Responses-to-Comments Table

**Proposed Amendment to the Approved Kwu Tung South Outline Zoning Plan No. S/NE-KTS/22 From “Agriculture” Zone and “Green Belt” Zone to “Government, Institution or Community” Zone at Various Lots in D.D.94, 98 & 100 and Adjoining Government Land, Kwu Tung South, New Territories (TPB Ref. Y/NE-KTS/18)**  
**Responses to Comments Table**

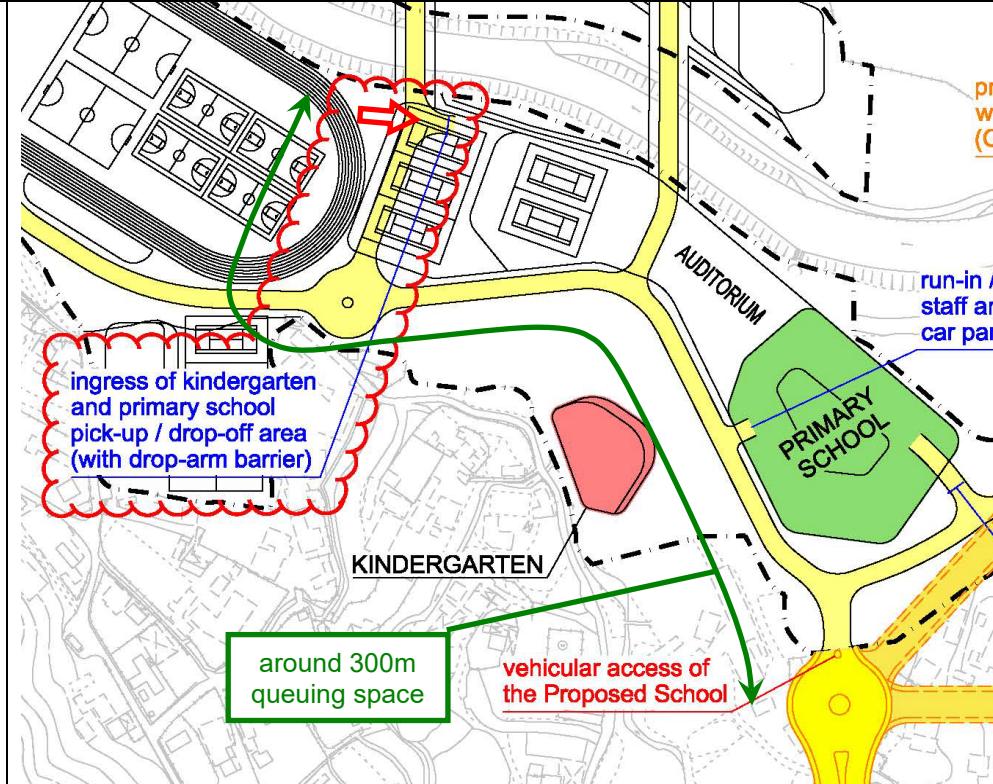
f. Section 3.18 – It is noted that approximately 300 meters are proposed within the school for queuing of vehicles. However, according to the master layout plan attached in the planning application, the proposed location of the kindergarten and primary school is close to the vehicular access. Please clarify the location of the pick-up and drop-off area for private cars for the kindergarten and primary school, and demonstrate that parent vehicles will not queue back to the local road and slip road of the NMH.	As shown in the below diagram extracted from Figure 3.1 of the submitted Traffic Review Report in Appendix 4, the ingress of pick-up / drop-off area for kindergarten and primary school ( <u>indicated in red coloured cloud and red arrow</u> ) is located around 300m from the vehicular access:

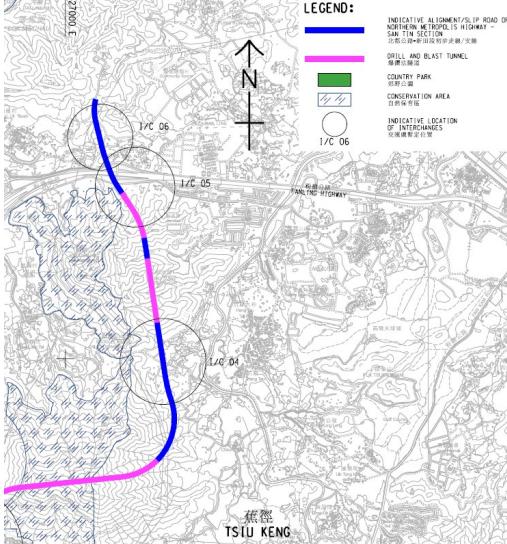
Comments/ Suggestions	Applicant/ Consultant's Responses
<p>3. The ecological review at Appendix 6 is preliminary in nature and cannot support evaluations of potential ecological impacts arising from the proposed development at this stage. The applicant is advised to conduct a detailed ecological impact assessment (EcoIA) including ecological baseline surveys covering the wet and dry seasons. For general requirements for an EcoIA, reference should be made to Annexes 8 and 16 of the Technical Memorandum on Environmental Impact Assessment Process and Environmental Impact Assessment Ordinance Guidance Notes No. 7/2023 and No. 10/2023. The EcoIA should also take into account how construction materials will be transported to the site and whether any haul roads or traffic roads will need to be constructed by the applicant for the proposed development.</p> 	<p>The Rezoning Site is not considered ecological sensitive with reference to the findings on the agricultural uses of two relevant studies in the vicinity, namely:</p> <ol style="list-style-type: none"> <li>(1) The ‘Report on Preliminary Technical Study (Final) – Engineering Feasibility Study for the Establishment of an Agricultural Park – Feasibility Study (Feb 2017)</li> <li>(2) Northern Metropolis Highway – San Tin Section (Project Profile) under EIAO, April 2025</li> </ol> <p>In particular, the proposed Interchange No. I/C 04 is located next to the Site, as indicated below.</p>
